NSL 5/6/98
SDX RESOURCES, INC.

This letter is intended to serve as an application for administrative approval of an unorthodox drilling location on our Culwin 35 Federal lease. The location requested will be the Culwin 35 Federal #4. Survey plats and BLM 3160 forms accompany this letter. A map detailing the lease is also enclosed. The location was moved 50' north at the BLM's direction due to it's proximity to an existing pipeline. The new location will be 280' south of an internal proration unit line. Ownership in both of the affected 40 acre proration units is identical and no other operator will be affected by the proposed location. Thanks for your prompt attention on this matter.

*Re: Application for administrative approval to drill the
Culwin "35" Federal Well No.4 at an unorthodox
oil well location within the Shugart-Yates-Seven
Rivers-Queen-Grayburg Pool 1040 feet from the
South line and 330 feet from the East line (Unit P)
of Section 35, Township 18 South, Range 30 East,
NMPM, Eddy County, New Mexico.*

Re: Administrative Approval
Culwin 35 Federal #4
Eddy Co., NM

WELL LOCATION AND ACREAGE DEDICATION PLAT

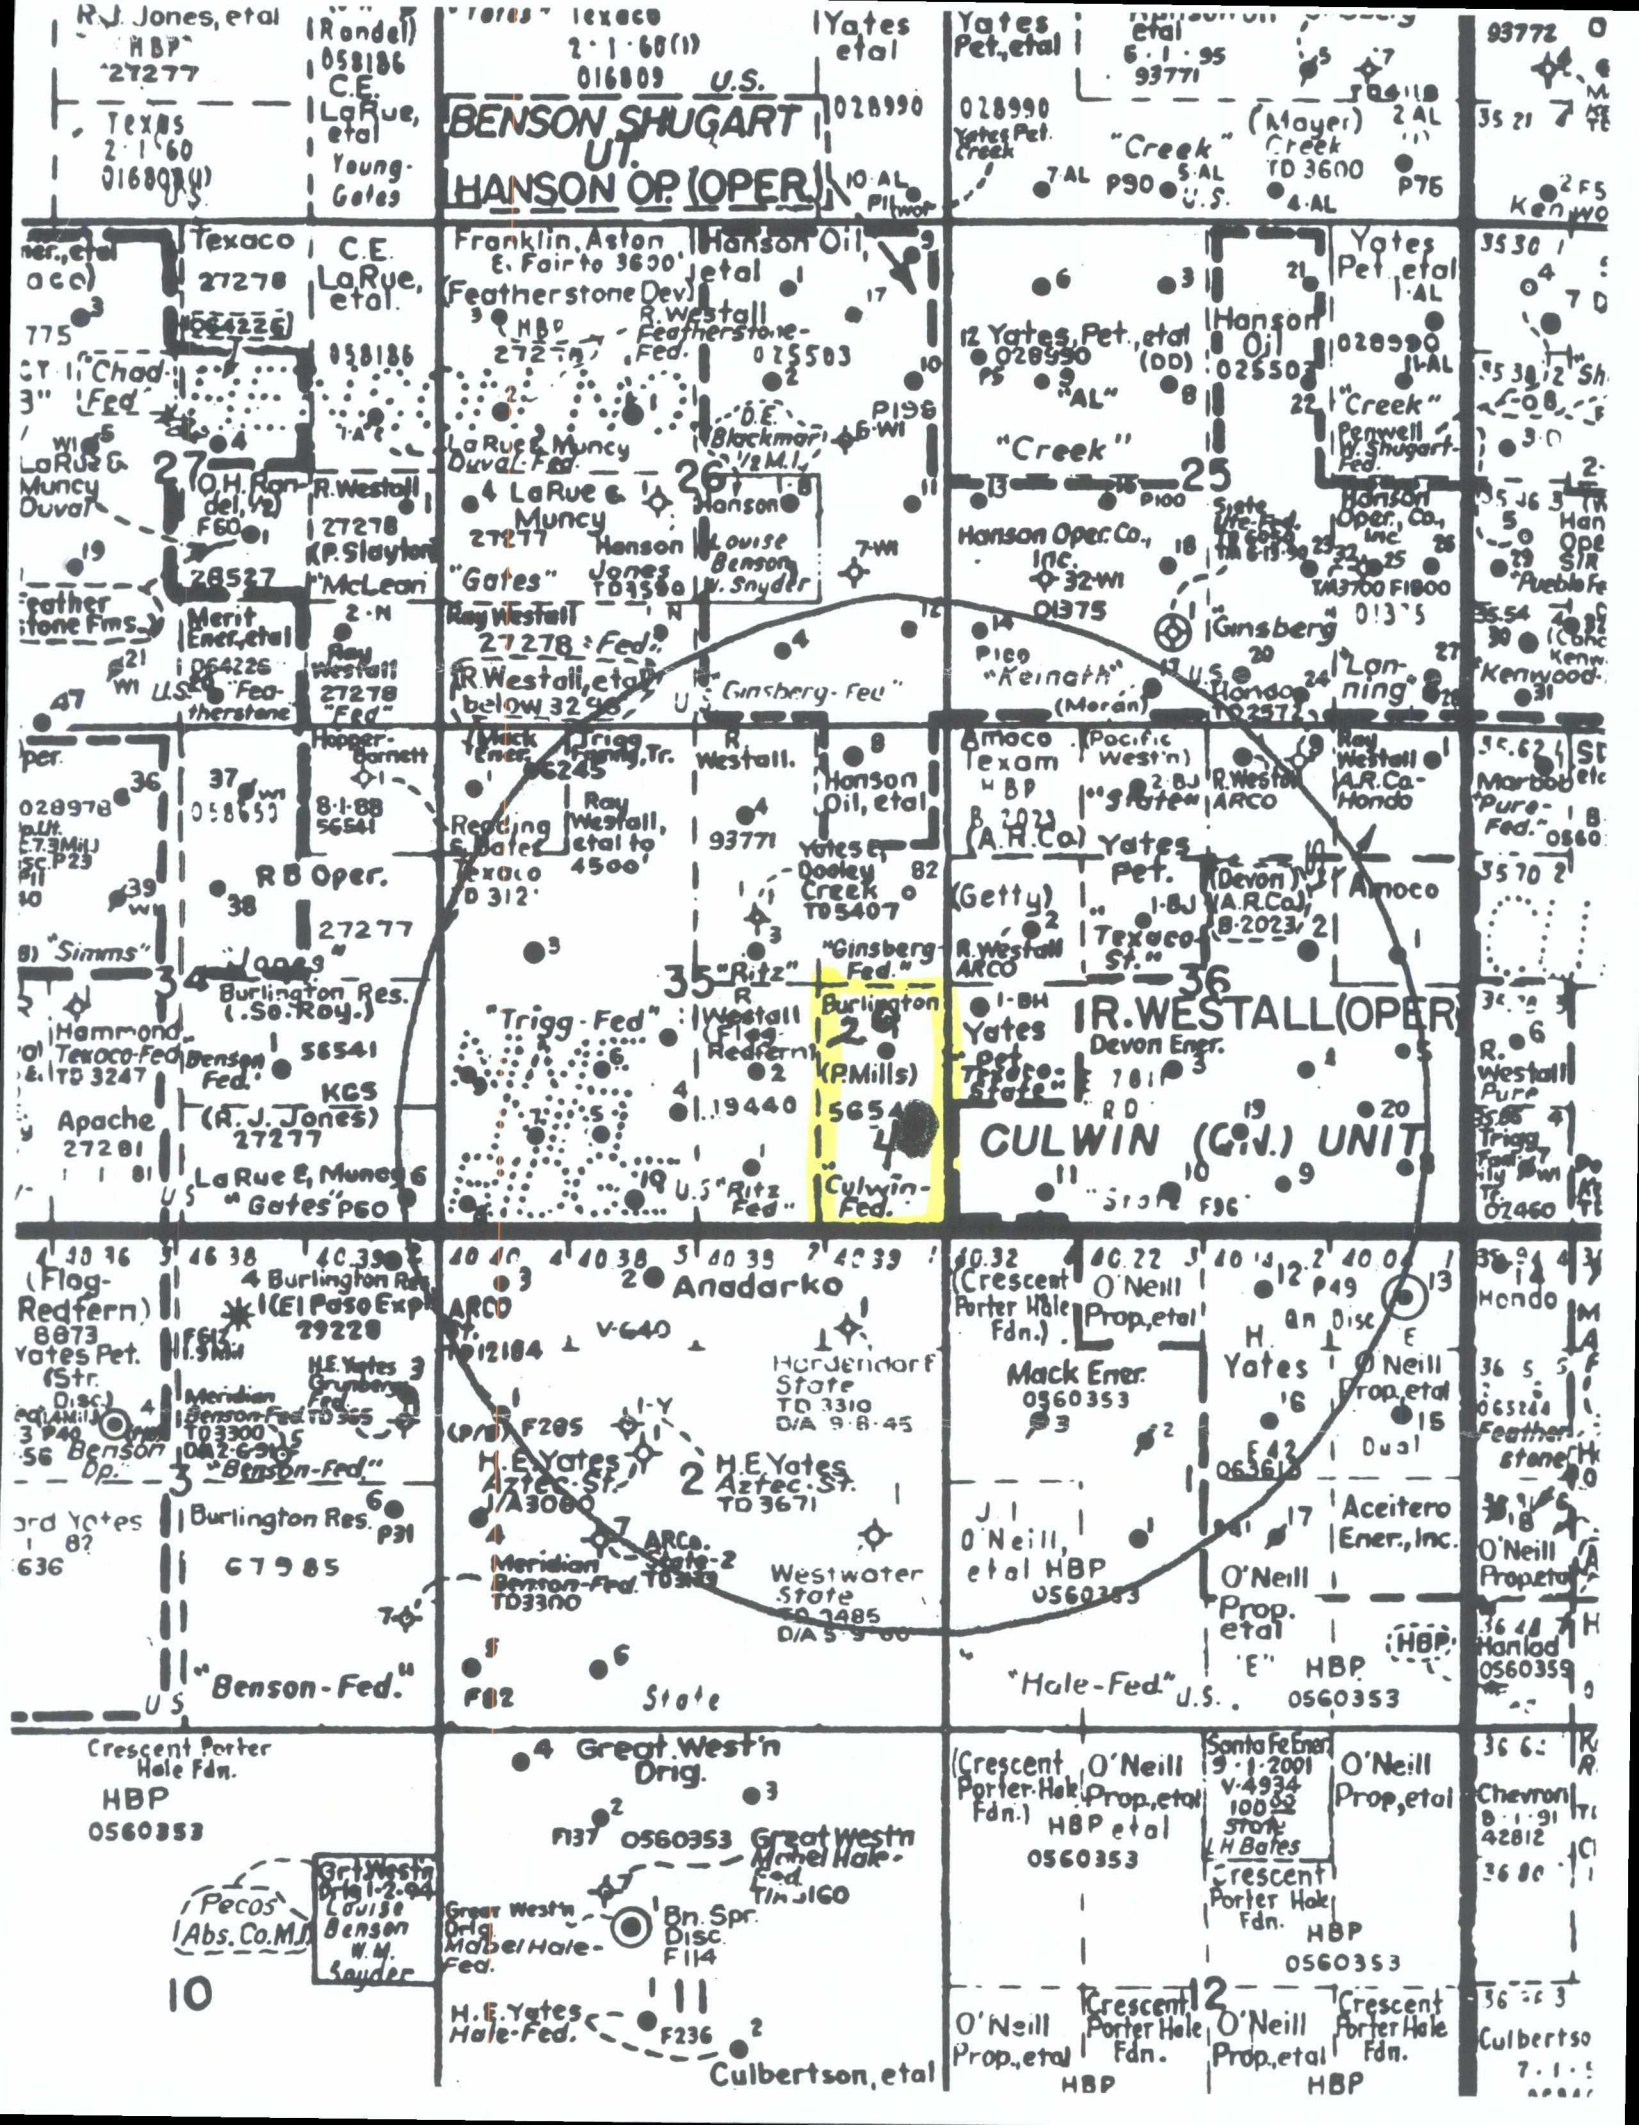
Please supplement the subject application with the appropriate information to justify the drilling of this well at an unorthodox oil well location within the subject 40-acre tract. Please refer to Division Rule 104.F(3) and submit a detailed explanation and show on attached plats why all other possible standard locations are not available to SDX Resources, Inc. for a drilling location.

Drainage patterns and Cave Kart areas raise BLM concerns and make their approval of any locations in the entire S/2 of unit P doubtful at best. Relief concerns eliminate the entire W/2 of the unit. This leaves only the NE/4 of unit P for the location of a well pad that will conform to BLM requirements. The standard location would have been 990' FSL & 330' FEL, but this fell 50' north of an existing pipeline. Moving the location 150' south was not possible due to the large amount of relief, so we moved the location 50' north (100' north of the pipeline) giving us an unorthodox location of 1040' FSL & 330' FEL.
